SUBJECT: CHANGES TO TECHNICAL SPECIFICATIONS REGARDING LICENSEE'S ORGANIZATION (TAC NO. 64965)

RE: GRAND GULF NUCLEAR STATION, UNIT 1

AMENDMENT TO FACILITY OPERATING LICENSE

Amendment No. 33
License No. NPF-29

FIGURE 6.2.1-1 OFFSITE ORGANIZATION

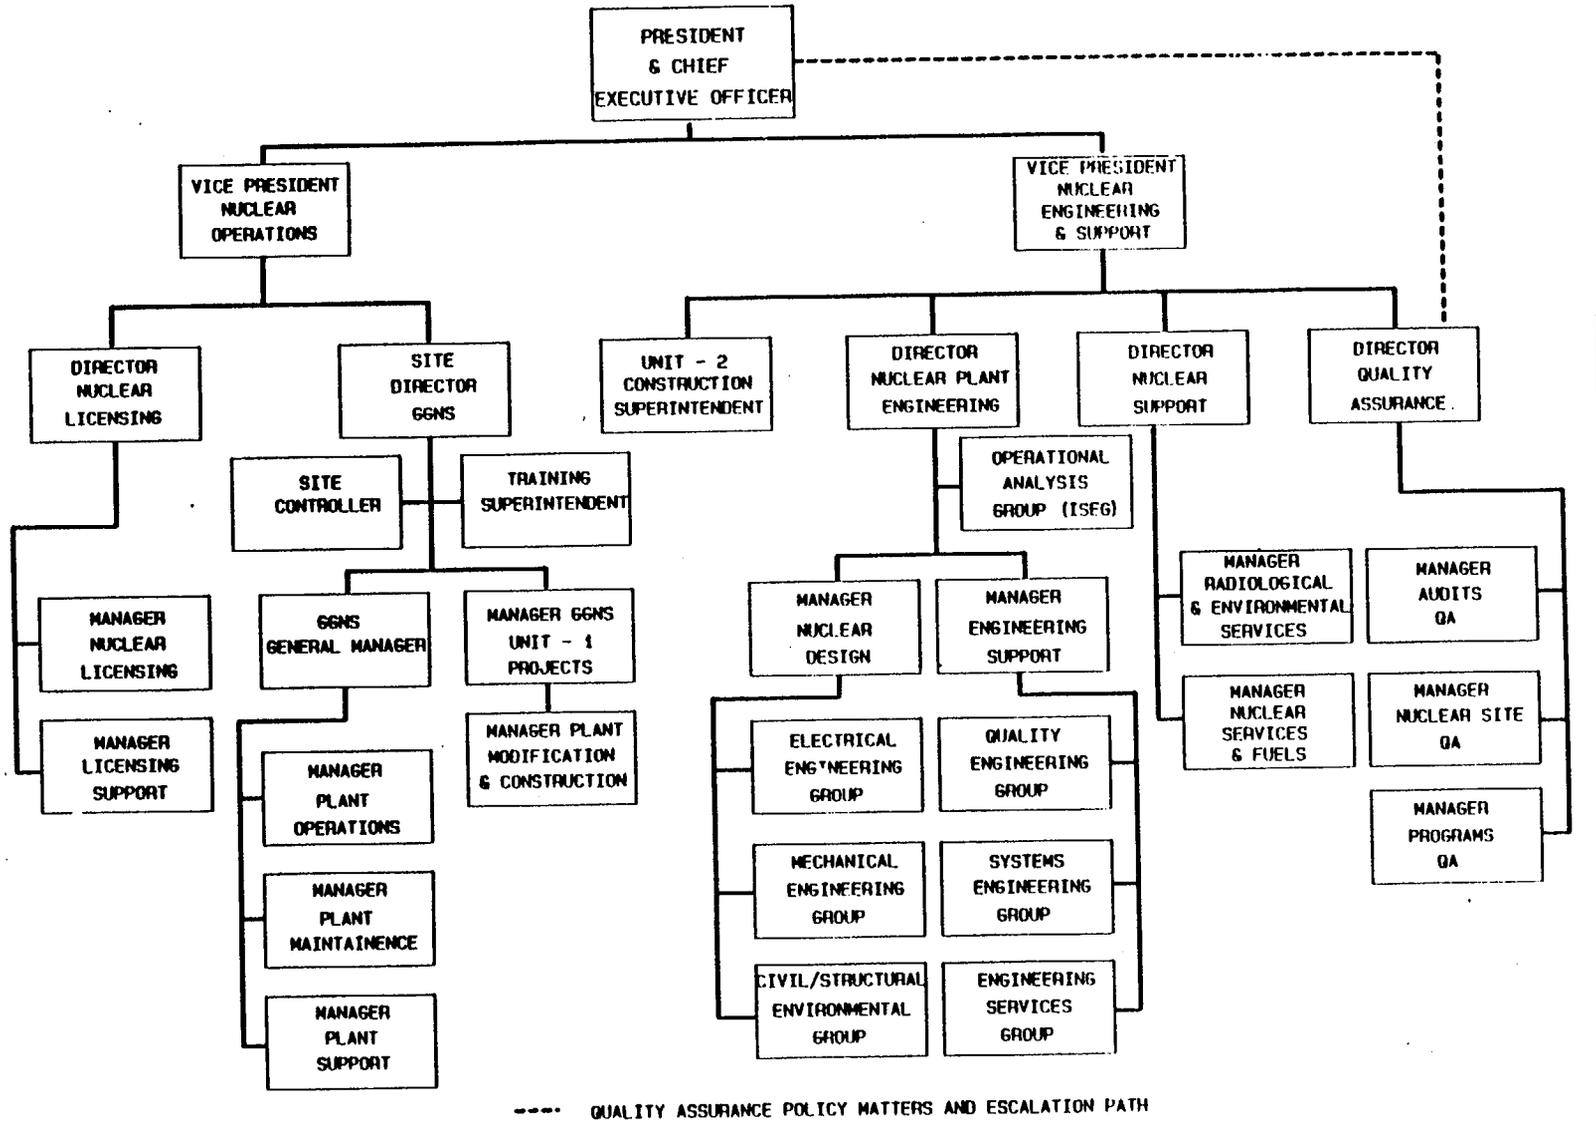
The organization under the Vice President Nuclear Operations has been revised to redefine the functions and change the title of Director Nuclear Licensing and Safety to Director Nuclear Licensing. The title for the Manager Nuclear Safety and Compliance, who reported to the Director Nuclear Safety and Licensing, has been changed to Manager Licensing Support and will report to the Director Nuclear Licensing. The reorganized department will retain all of the responsibilities of the former Nuclear Licensing and Safety Department with the exception of the emergency planning area which will be the responsibility of the Assistant to the Vice President, Nuclear Operations.

The organization under the Director Nuclear Plant Engineering, who reports to the Vice President Nuclear Engineering and Support, has been revised to establish the two new positions of Manager Nuclear Design and Manager Engineering Support. Reporting to the Manager Nuclear Design is the current Electrical Engineering Group, Mechanical Engineering Group, and the Civil/Structural Environmental Group. Reporting to the Manager Engineering Support is the current Quality Engineering Group, Systems Engineering Group, and the Engineering Services Group.

We find the changes to the Offsite Organization acceptable because they do not delete any of the technical support for Grand Gulf Unit No. 1 and the organization meets the acceptance criteria of Section 13.1 of NUREG-0800, the Standard Review Plan.
